MEMORANDUM

DATE:	October 9, 2020
то:	Newbury Zoning Board of Appeals
FROM:	Ann M. Marton, Director of Ecological Services
RE:	Comprehensive Permit Application and Site Plan Peer Review Village at Cricket Lane, Newbury, Massachusetts
LEC File#:	ToNew\17-300.02

Peer Review Comments The Village at Cricket Lane Wetland Details (sheet 16) Last revised 8/17/2020

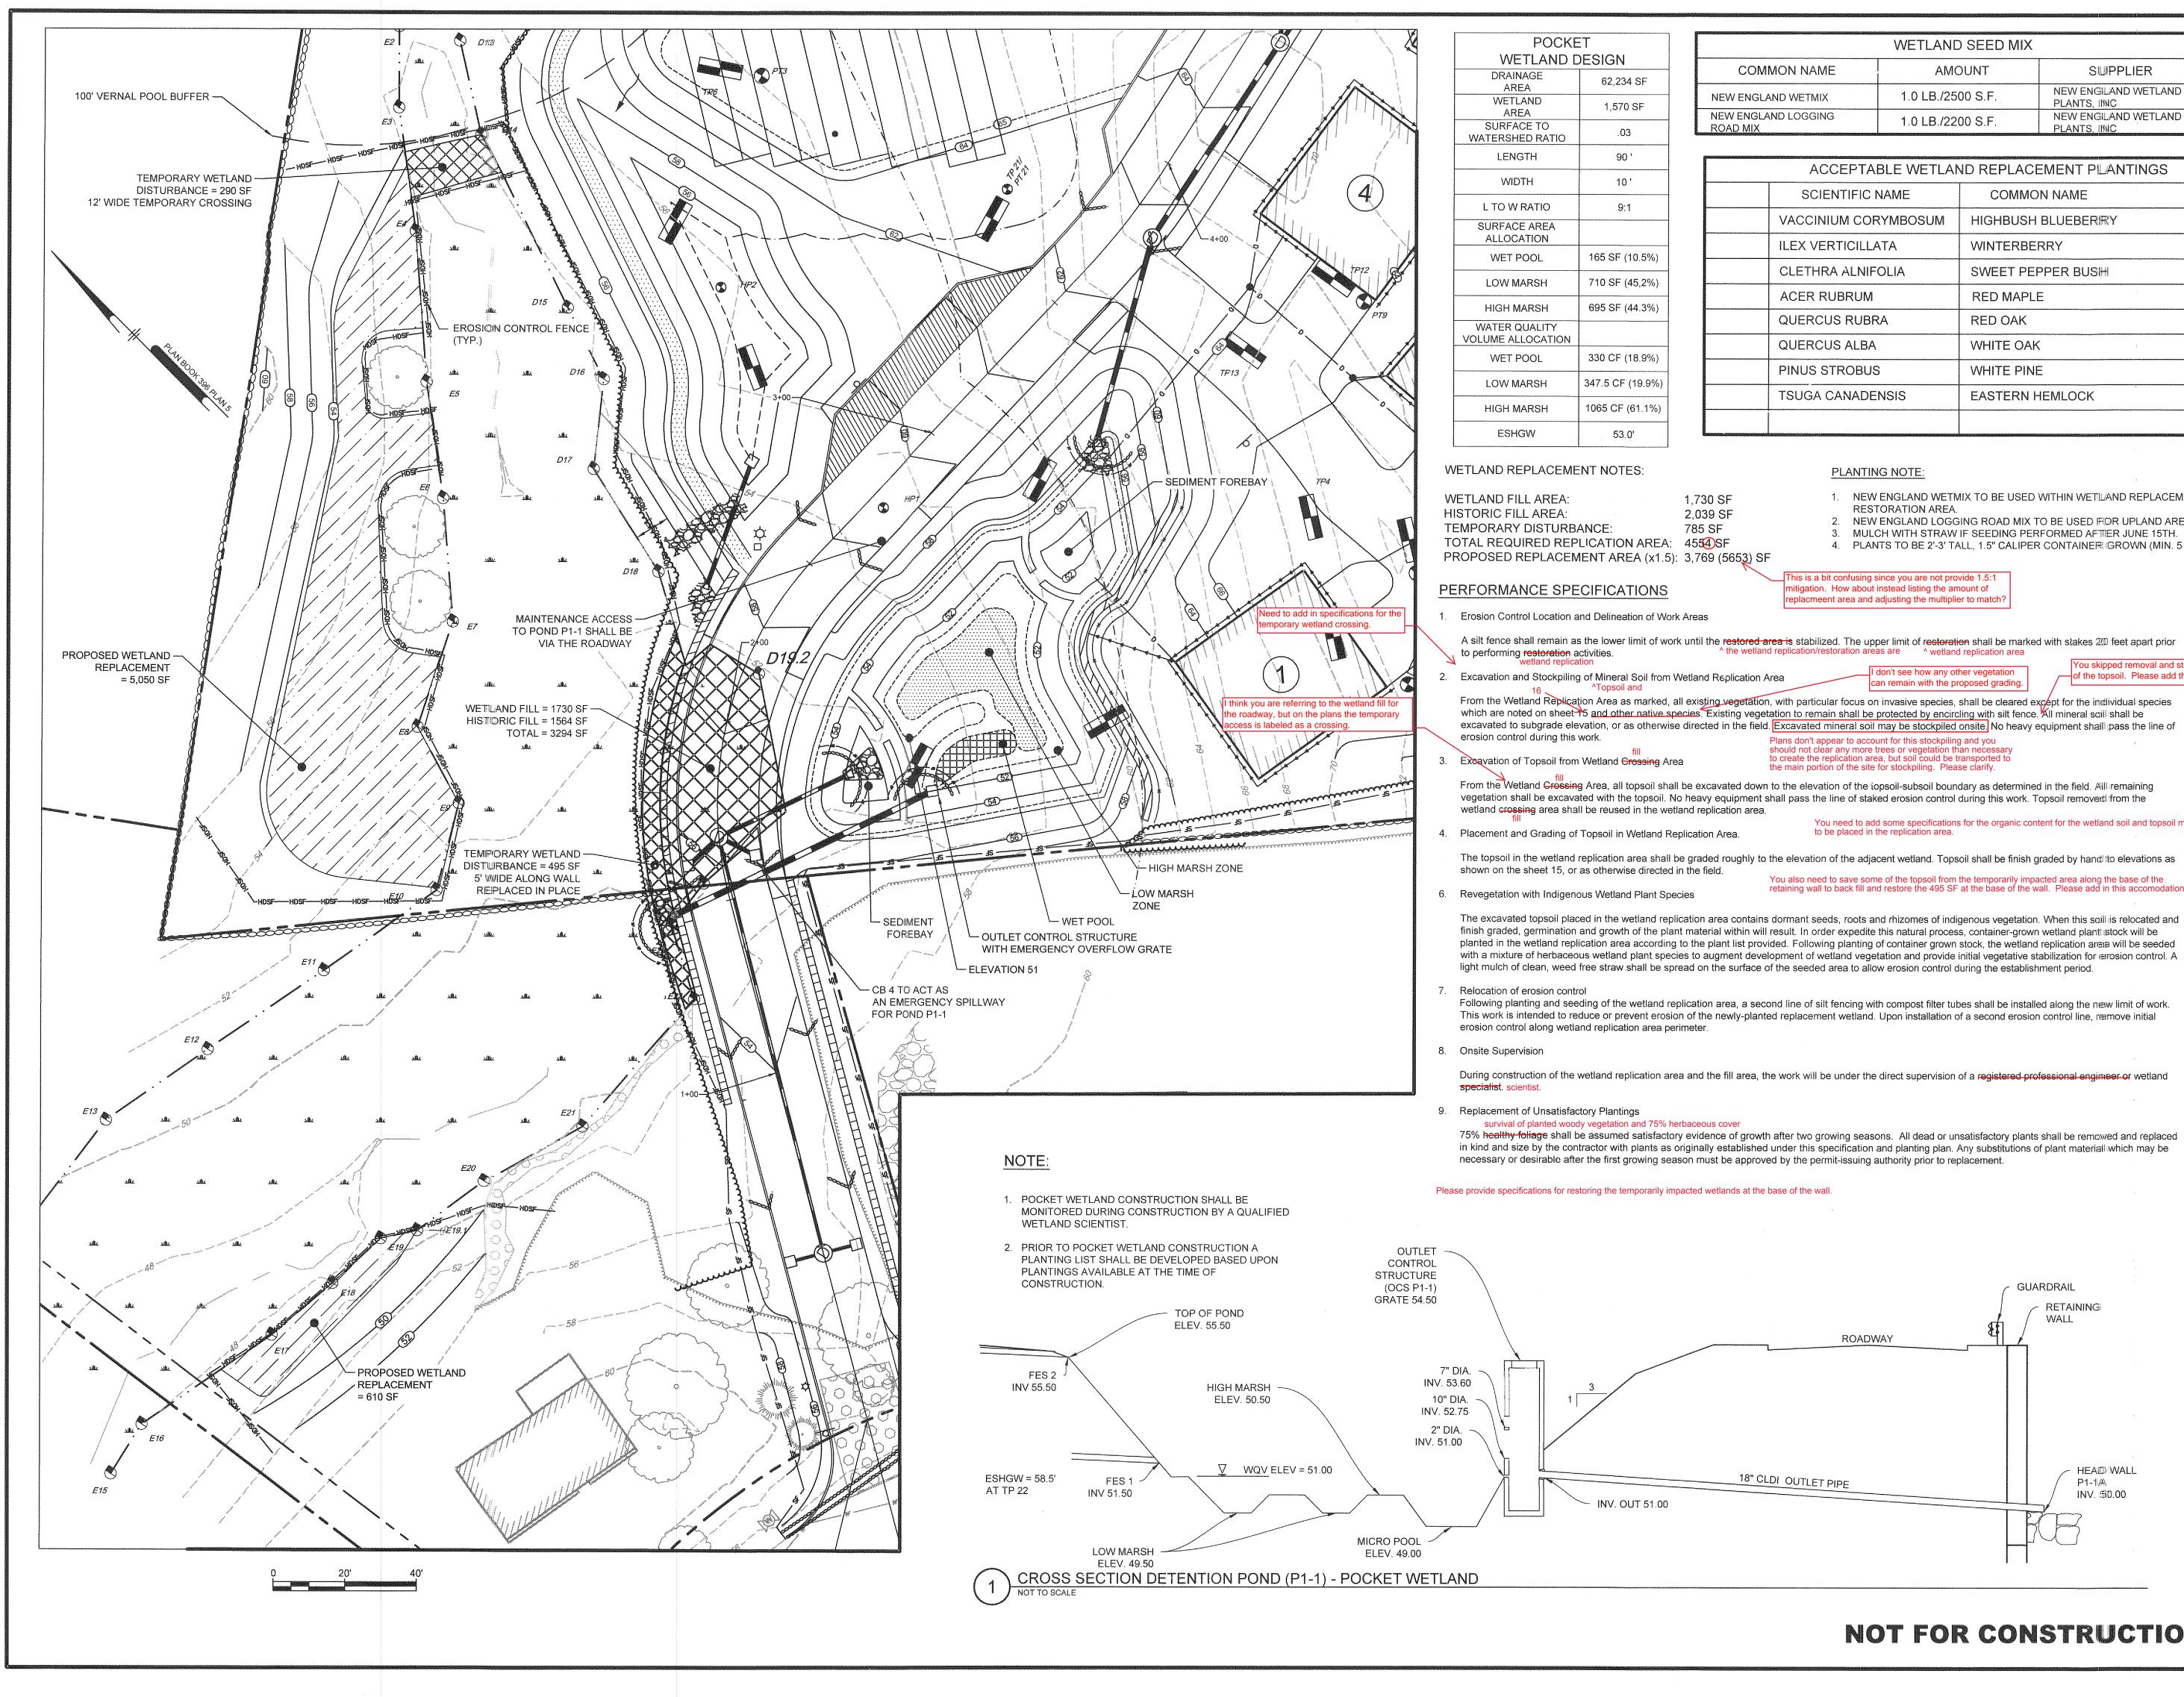
The Wetland Details plan (sheet 16) depicts a proposed 5,050 SF Wetland Replacement Area with grading, tree protections to the presumed drip line for 3 existing trees, a Wetland Replacement Planting Table, Wetland Seed Mix, and Performance Specifications. While this is a vast improvement, the Wetland Replacement Table omits the number of required trees and shrubs to confirm proper planting densities, and includes eastern white pine (*Pinus strobus*) which is not a wetland plant. Please add tree and shrub quantities and either remove *P. strobus* or replace with a more appropriate tree species. Additionally, see Attachment A for LEC's markup comments on Sheet 16.

WETLAND	SEED MIX		
COMMON	NAME	AMC	DUNT	SWPPLIER	
NEW ENGLAND W	TMIX	1.0 LB./25	00 S.F.	NEW ENGILAND WETLAND PLANTS, IINC	
NEW ENGLAND LO ROAD MIX	GGING	1.0 LB./22	00 S.F.		
				ринектеникалыкан казактан казактан казактан ка	
	ACCEPTABL	E WETLAN	ND REPLACE	EMENT PILANTINGS	Ranger E
	SCIENTIFIC NAM	МЕ	соммо	N NAME	Methuen M Tel: 978-208-
VAC	CINIUM CORYN	IBOSUM	HIGHBUSH	BLUEBERRY	rangereng.
(LE)	K VERTICILLATA	۱.	WINTERBEI	RRY	
CLE	THRA ALNIFOL	IA	SWEET PEF	PPER BUSH	
ACI	ER RUBRUM		RED MAPLE	an a	
QUE	ERCUS RUBRA		RED OAK		
QUE	ERCUS ALBA	annonnannannanna areisis ann a sua	WHITE OAK	1	
PIN	US STROBUS		WHITE PINE		
TSL	IGA CANADENS	IS	EASTERN H	IEMLOCK	
		Man (1997) - Anno (antenin suur se anna anna anna anna anna anna anna a		
730 SF 039 SF 35 SF	RESTOR 2. NEW EN	GLAND WETN ATION AREA. GLAND LOGG	ING ROAD MIX T	WITHIN WETLAND REPLACEMEN O BE USED FOR UPLAND AREAS FORMED AFTTER JUNE 15TH.	
55 <mark>4)</mark> SF 769 (565 <u>3</u>) SF	4. PLANTS	TO BE 2'-3' TA	ALL, 1.5" CALIPER	CONTAINER GROWN (MIN. 5 GA	λL.)

This	s is a bit confusing since gation. How about inste acmeent area and adjus	ad listing the am	nount of		
	tabilized. The upper l	imit of restorati	on shall be marked	I with stakes 20 feet apart prior	
^ the wetland replica	tion/restoration areas ar	e ^ wetland	d replication area	You skipped removal and stock	
and Replication Area		see how any ot main with the pr	her vegetation oposed grading.	of the topsoil. Please add this	in.
ected in the field. Excav Plans do should r to create	remain shall be prote	ected by encirc be stockpiled or this stockpiling or vegetation th ut soil could be t	ling with silt fence. onsite. No heavy e g and you an necessary ransported to	cept for the individual species All mineral sail shall be equipment shall pass the line of	OKE1
excavated down to the	elevation of the topso	il-subsoil boun	dary as determined	in the field. All remaining opsoil removed from the	E AT CRI((NEWBURY), MA

ation Area.	You need to add sor to be placed in the re	ne specifications eplication area.	s for the organic cont	ent for the wetland soil and topsoil mix

You also need to save some of the topsoil from the temporarily impacted area along the base of the

retaining wall to back fill and restore the 495 SF at the base of the wall. Please add in this accomodation.
